Agenda Item # R - 11

Village of Royal Palm Beach
Village Council
Agenda Item Summary

PUBLIC HEARING TO CONSIDER APPLICATION NO. 23-019 (LW), AN APPLICATION BY URBAN DESIGN STUDIOS, FOR THE CONSIDERATION OF SEVEN (7) LANDSCAPE WAIVERS FOR POD 6 WITHIN MAIN STREET AT TUTTLE ROYALE INCLUDING WAIVERS TO ALLOW BUFFER ENCROACHMENT, OFF-CENTER TREE SPACING IN BUFFERS, INCREASED TREE SPACING IN DIVIDER STRIPS, SHORTER TERMINAL ISLAND LENGTHS, ELIMINATION OF TREES WITHIN CERTAIN TERMINAL AND DOUBLE TERMINAL ISLANDS, AS SET FORTH MORE SPECIFICALLY BELOW, FOR A PROPERTY LOCATED SOUTH OF SOUTHERN BOULEVARD APPROXIMATELY 0.27 MILES WEST OF STATE ROAD 7 (US 441).

Directly Below is an illustration showing the location of the Waiver #1 request.

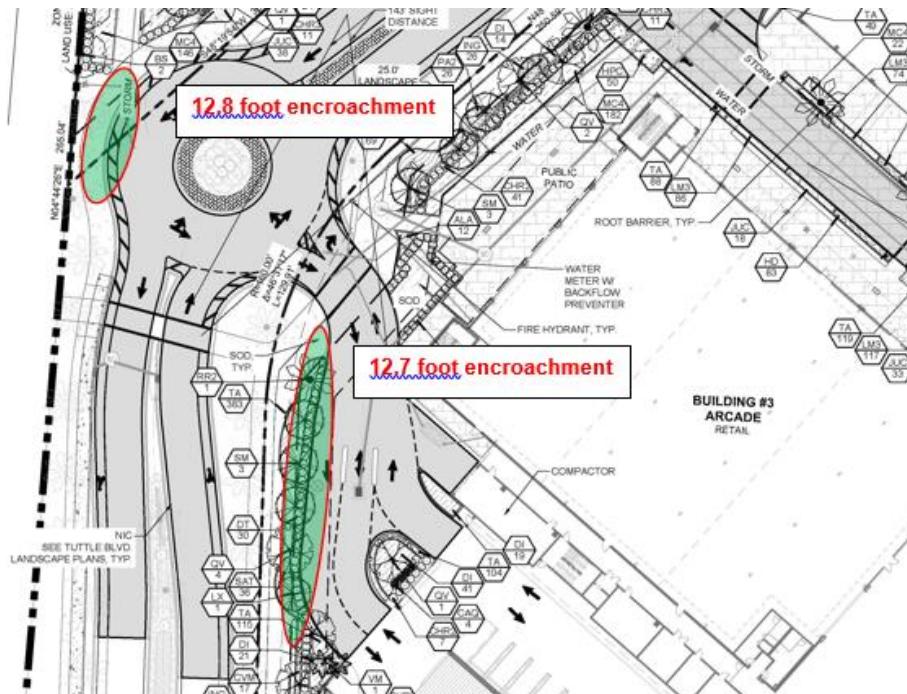
Waiver from Sec. 15-131(b) to allow a 12.7 and 12.8 foot drive aisle encroachment into the western 25 foot landscape buffers. The purpose of Waiver #1 is to allow a 12.8 foot drive aisle encroachment into the required 25 foot Perimeter Landscape Buffer south of Building 8 and a 12.7 drive aisle encroachment into the required 25 foot Perimeter Landscape Buffer west of Building 3. Please see below the areas of these encroachments.

The Applicant Contends: “The existing drive aisle configurations managed to stay outside of the landscape buffer but also raised concerns in the staff review process that there would be a conflict with the location of the southern roundabout on Tuttle Blvd in which the drive aisle was designed to turn into. To address this concern, the roundabout has been reworked to encroach into the landscape buffer to allow a safer and more efficient traffic flow. The 12.7’ drive aisle encroachment directly west of building 3 also was designed to improve the ingress into Garage 3 with a revised geometry that makes for a more naturally angled turn into Garage 3. The intent of the landscape buffers continue to be met with both drive aisle encroachments as the landscaping being lost in the areas is being offset by enhanced landscaping provided in the open area south of the drive aisle. The residential property to the west also has a landscape buffer on its site providing screening and privacy to those units. Similarly to waiver requests also contain sufficient planting to screen the view of the garage and entry drive from Tuttle Blvd.”

Staff Recommendation: Staff is recommending Approval of Landscape Waiver #1 and generally concurs with the Applicant’s assessment. Staff believes that this is the minimum waiver necessary to allow reasonable use of the property.

Please see below the areas of these encroachments for Waiver #2 highlighted in green.

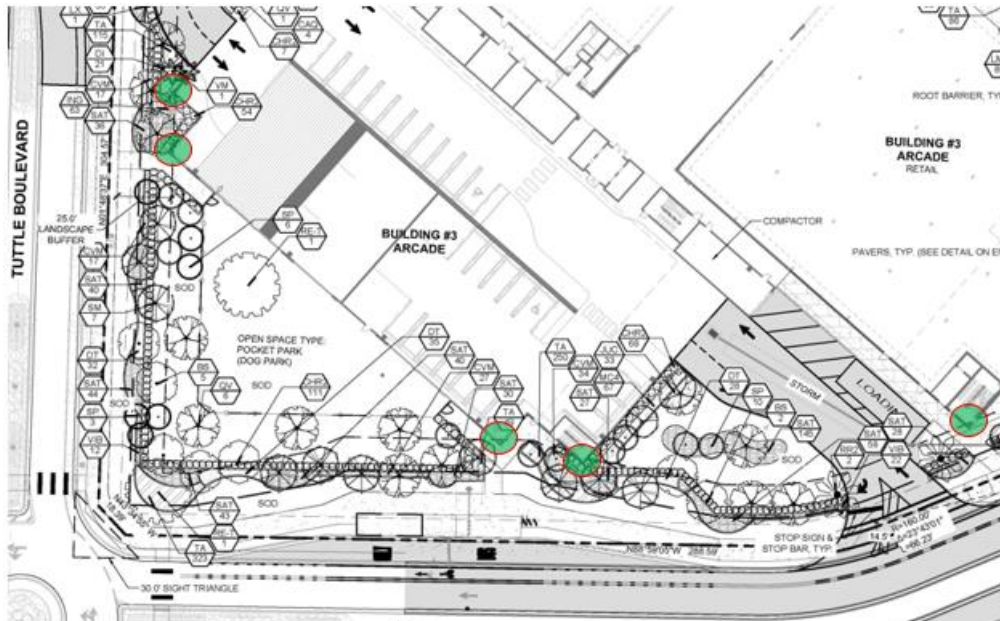
Waiver from Sec. 15-131 (c) to allow the encroachment of Building 3 into the Perimeter Landscape Buffers. The purpose of Waiver #2 is to allow the encroachment of Building 3

into the Perimeter Landscape Buffers along Tuttle Boulevard to the west and Erica Boulevard to the south at five (5) locations. Encroachment 1 is 0.5 feet and Encroachment 2 is 2.1 feet along Tuttle Boulevard; Encroachment 3 is 2.6 feet; Encroachment 3 is 2.2 feet, and Encroachment 3 is 2.7 feet along Eric Boulevard.

The Applicant Contends: *“The building envelope and sizes are necessary to allow the design of code compliant parking dimensions and drive aisle dimensions, as such the design of the Building 3 garage increased. Although the garage encroaches in these designated areas, landscape plantings are not negatively affected and the plant material as proposed will not be impeded in properly screening the subject property from the Erica Blvd and Tuttle Blvd rights of way.”*

Staff Recommendation: Staff is recommending Approval of Landscape Waiver #2 and generally concurs with the Applicant’s assessment. Staff believes that this is the minimum waiver necessary to allow reasonable use of the property.

Please see below an illustration of the landscape pattern for the Perimeter Landscape Buffer along Southern Boulevard east of Tuttle Boulevard for Waiver #3.

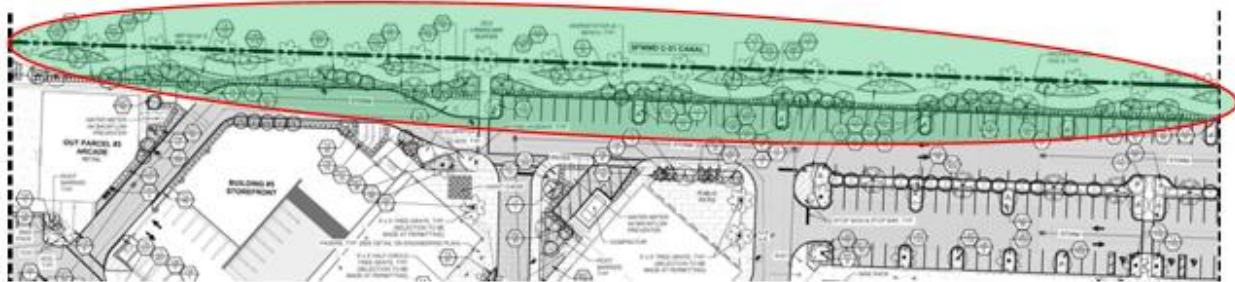
Waiver from Sec. 15-131 (d)(3) to allow for the required canopy trees to be placed not on center within the northern Perimeter Landscape Buffer along Southern Boulevard east of Tuttle Boulevard where Village Code requires canopy trees to be spaced 20 feet on center.

The Applicant Contends: *“The intent of the code is being met as the overall canopy tree quantity requirement in the northern perimeter buffer is being met with 110 trees required within the 2,194’ buffer length, with the average spacing also being met at 20’ per tree over the 2,194’ buffer length. The specific waiver request is to the requirement that the trees are planted “on-center”. Canopy trees at varying heights and species are provided to complement the Royal Palms along the northern perimeter buffer in the pockets of landscaped area south of the 10’ undulating shared-use path, however undulation of the multi-use walking path prevents the consistent spacing of the planted trees with the exception of the Royal Palms from being planted on center. The canopy trees along the undulating path are instead planted in converged pockets of space where available along the path. The walking path also provides a recreational benefit for residents of Main Street at Tuttle Royale to enjoy and stay active on. As mentioned previously, the intent of the code is still being met as the tree quantity required per section 15-131 (d)(3) is still being met at 110 trees required and 110 trees provided.”*

Staff Recommendation: Staff is recommending Approval of Landscape Waiver #3 and generally concurs with the Applicant’s assessment. Staff believes that this is the minimum waiver necessary to allow reasonable use of the property.

Please see below an illustration of the landscape pattern for the Perpendicular Divider Strips north of Building 9 and highlighted in green.

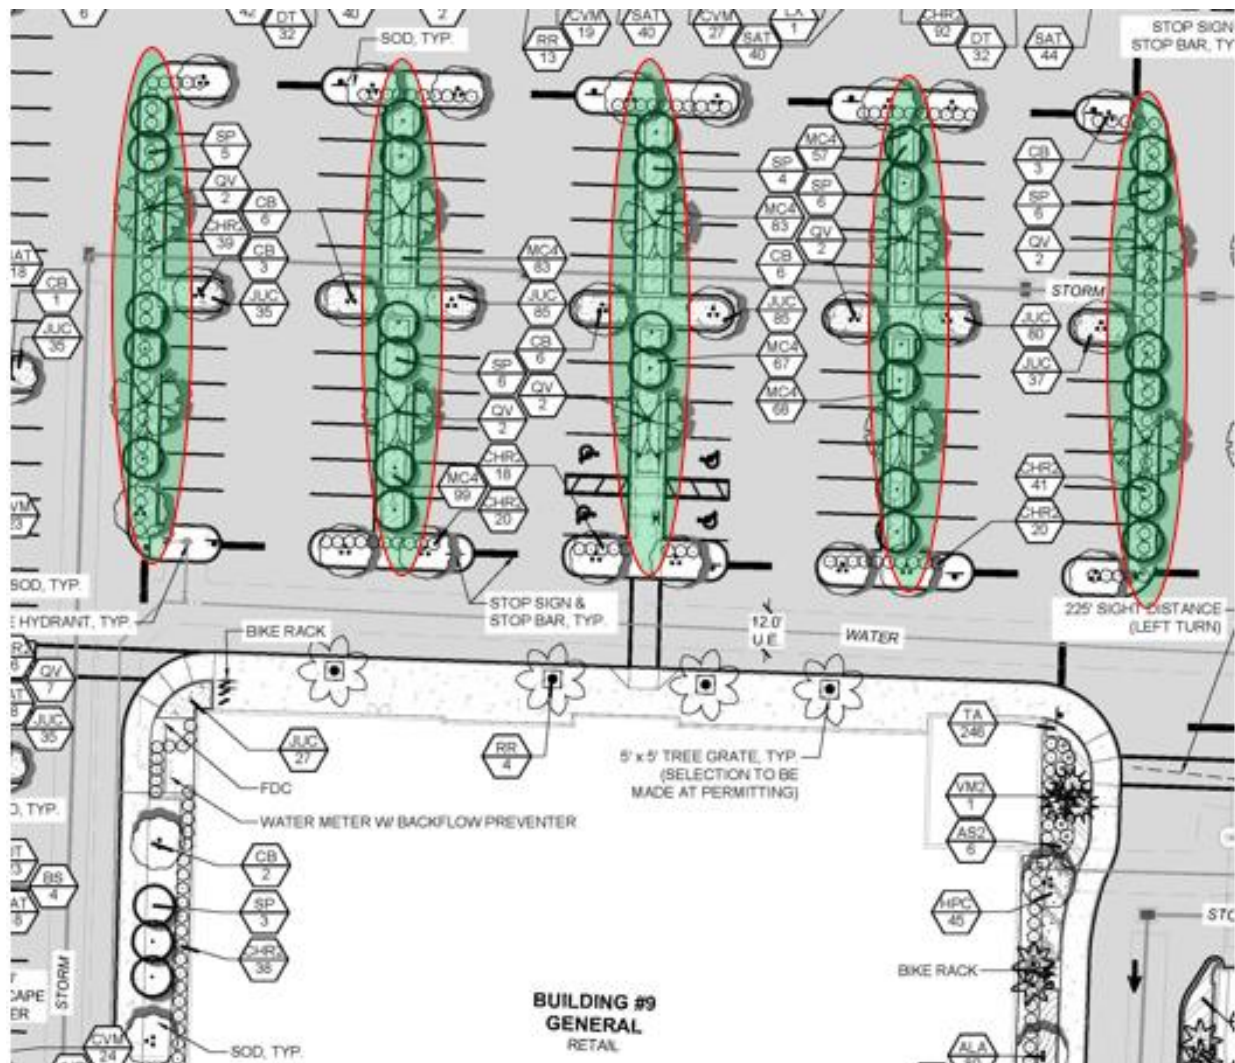
Waiver from Sec. 15-133 (b)(2) to allow an increase of the canopy tree spacing within the Perpendicular Divider Strips of up of 61 feet north of building 9; up to 59.9 feet north of Building 10; up to 65 feet north of Building 12, where Village Code requires canopy trees to be spaced a minimum of one (1) tree every 15 feet.

The Applicant Contends: *“The Applicant intends to use oaks within these divider medians in order to provide a richer and denser canopy throughout the parking areas and increase shade throughout. The code minimum of 15’ spacing restricts the ability to plant oaks in these areas since 15’ spacing would constrict and impact the room needed for root growth of trees of this quality. This allows the planting of oaks with safe root growth to further enhance the parking area landscaping. Sabal palms of varying heights are also being planted to fill in gaps in between the oak tree plantings. The sabal palms planted in between the Live Oaks do not count toward the tree quantity requirement in*

the landscape strip since they are not classified as canopy trees, however, they still provided added benefit in offering shade and enhanced landscaping along the parking area divider strips. It is also worth noting that waiver request 4A is required due to utility routing of the storm water drain north of Building 9 which intersects divider medians. This waiver allows the oaks to be planted with spacing that doesn't interfere with the stormwater drain and root growth."

Staff Recommendation: Staff is recommending Approval of Landscape Waiver #4 and generally concurs with the Applicant's assessment. Staff believes that this is the minimum waiver necessary to allow reasonable use of the property.

Please see below an illustration of the landscape pattern of the Terminal Landscape Island for the parallel parking areas along the square and are highlighted in green.

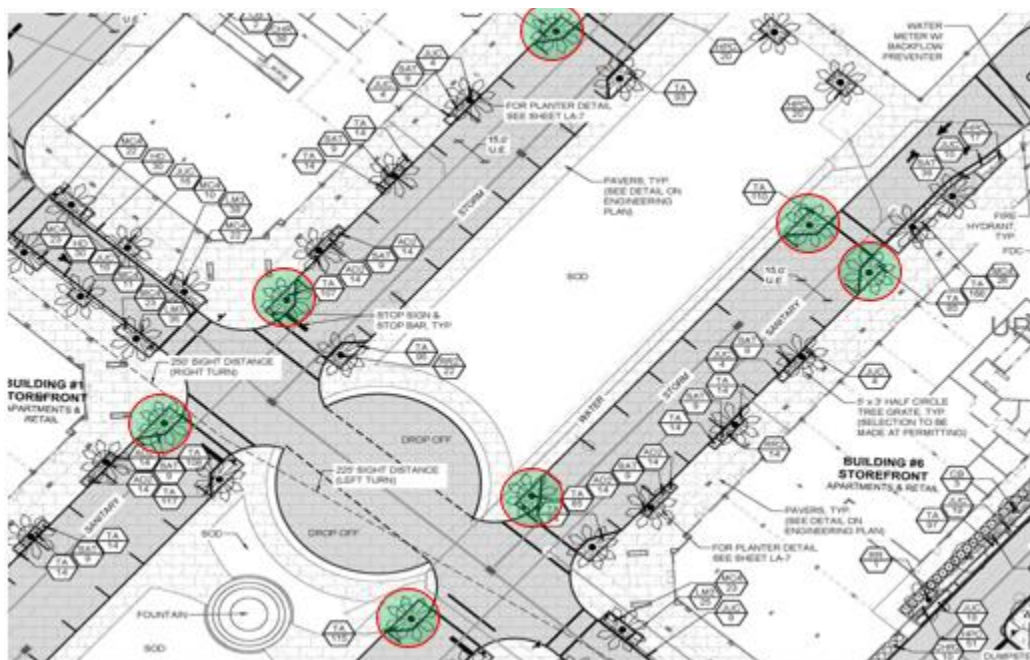
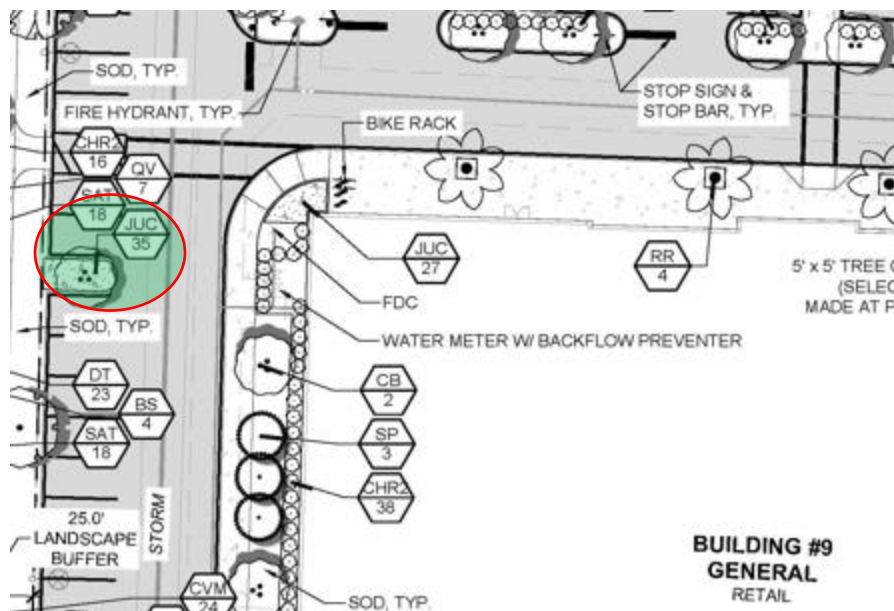
Waiver from Sec. 15-133 (d)(1) to allow Terminal Landscape Island for parallel parking rows to be less than the length of a parking space. The purpose of Waiver #5 is to allow Terminal Landscape Island ranging from 10.2 feet to 17.1 feet in length where Village Code requires Terminal Landscape Island to be a minimum of 20 feet in length resulting in a reduction between 2.9 feet and 9.8 feet in length. The parallel parking areas along the square will be the subject of Waiver #5.

The Applicant Contends: *"The terminal islands located at the ends of each parking row will be large enough to allow the planting of trees despite the substandard sizing. The stop signs have also been designed to be located in such a way that the tree plantings will be allowed to grow in a safe manner, meeting the intent of the landscape island. The*

cut out in the required size of the island is also due to the required space needed for the cars in the parallel spaces to properly pull out of the space.”

Staff Recommendation: Staff is recommending Approval of Landscape Waiver #5 and generally concurs with the Applicant’s assessment. Staff believes that this is the minimum waiver necessary to allow reasonable use of the property.

Directly below is an illustration showing the location of this Terminal Landscape Island and is highlighted in green.

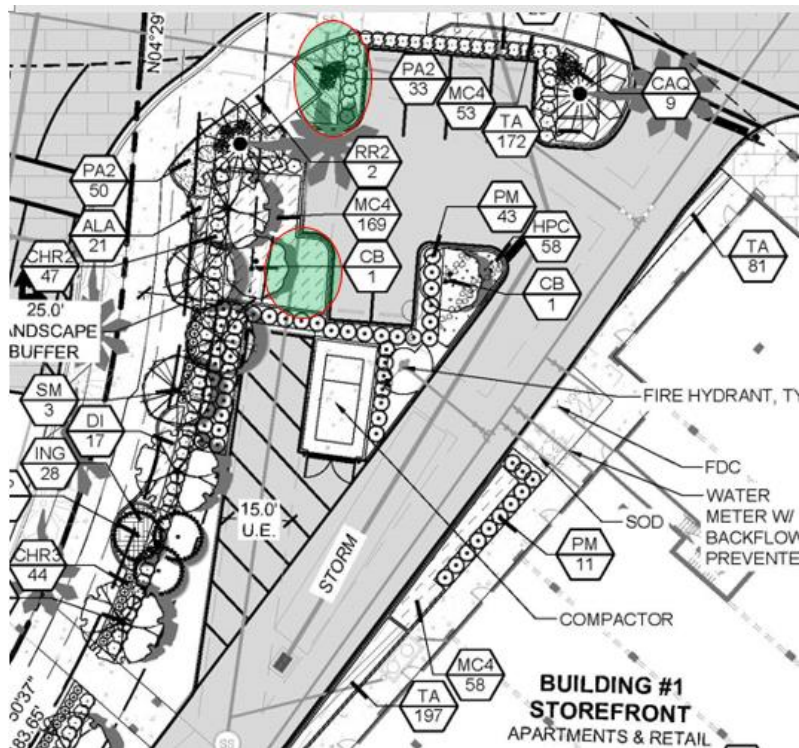
Waiver from Sec. 15-133 (d)(3) to allow the elimination of the required tree within the terminal islands at various locations. The purpose of Waiver #6 is to allow the elimination of one (1) canopy tree within the Terminal Landscape Island in four (4) locations.

Location 1 is the Terminal Landscape Island located furthest south and furthest west of the parking area north of Building 9. A fire hydrant is planned in this location which inhibits the ability to plant a tree within this Terminal Landscape Island. Directly below is an illustration showing the location highlighted in green.

Locations 2 and 3 are the Terminal Landscape Islands located west of a row of four (4) parking spaces and west of a row of two (2) parking spaces, situated to the west of Building 1. A Utility Easement is planned in these locations which inhibits the ability to plant a tree within these Terminal Landscape Islands.

The Applicant Contends: “Code compliant trees are proposed in all other terminal islands on the site, with the exception of the specific islands highlighted in the waiver request which are inhibited by utilities which would impact the root growth of any tree planted there and required separation from any storm drain to the tree trunk.”

Staff Recommendation: Staff is recommending Approval of Landscape Waiver #6 and generally concurs with the Applicant’s assessment. Staff believes that this is the minimum waiver necessary to allow reasonable use of the property.

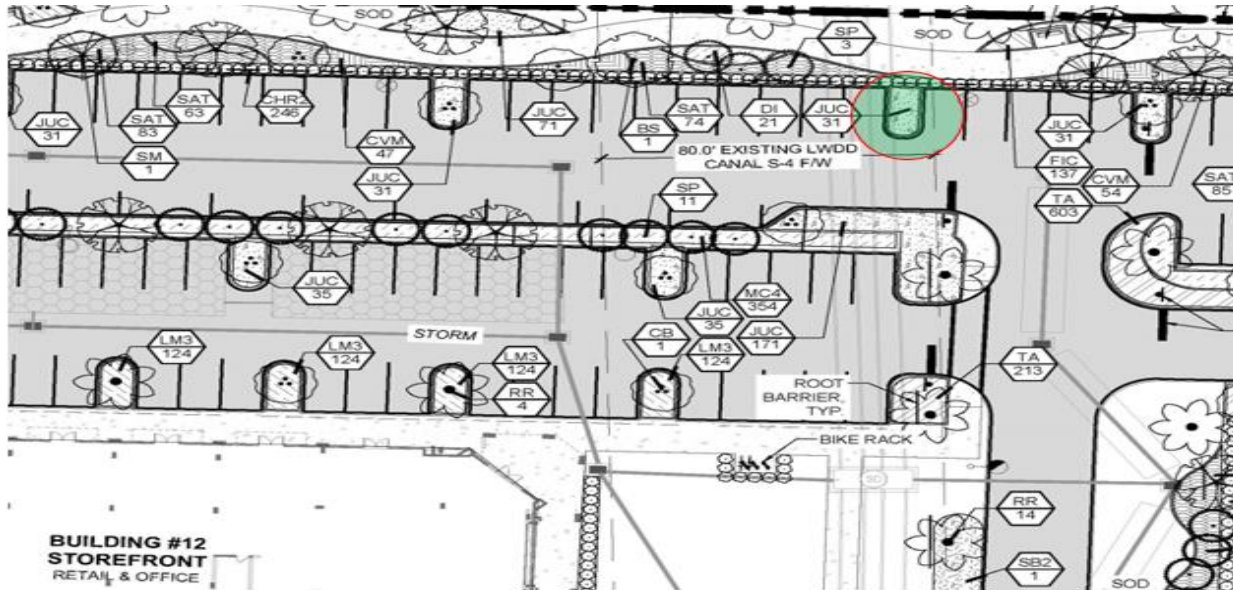
Location 4 is the Landscape Island located northeast of Building 12 in the row of parking spaces directly south of the Landscape Buffer along Southern Boulevard. A Utility Easement is planned in this location which inhibits the ability to plant a tree within this Landscape Island. Directly below is an illustration showing the location of this Terminal Landscape Island and is highlighted in green.

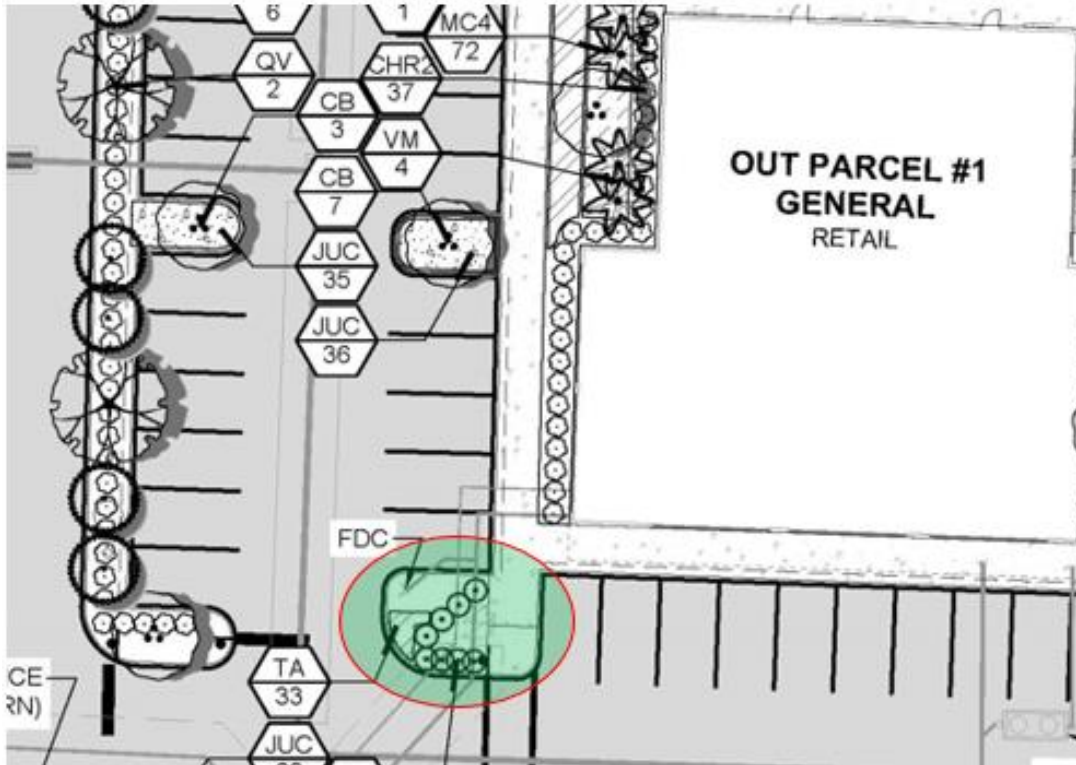
Waiver from Sec. 15-133 (d)(3) to eliminate the required trees within the double terminal island for the island southwest of Building OP- 1. The purpose of Waiver #7 is to allow the elimination of two (2) canopy tree within the Double Terminal Landscape Island located southwest of Building OP-1. Various mechanical equipment is planned in this location which inhibits the ability to plant a tree within this Landscape Island. Directly below is an illustration showing the location of this Terminal Landscape Island and is highlighted in green.

The Applicant Contends: “Code compliant trees are proposed in all other double terminal islands on the site. This specific island is inhabited by utilities which could impact the root growth of any tree planted there.”

Staff Recommendation: Staff is recommending Approval of Landscape Waiver #7 and generally concurs with the Applicant’s assessment. Staff believes that this is the minimum waiver necessary to allow reasonable use of the property.
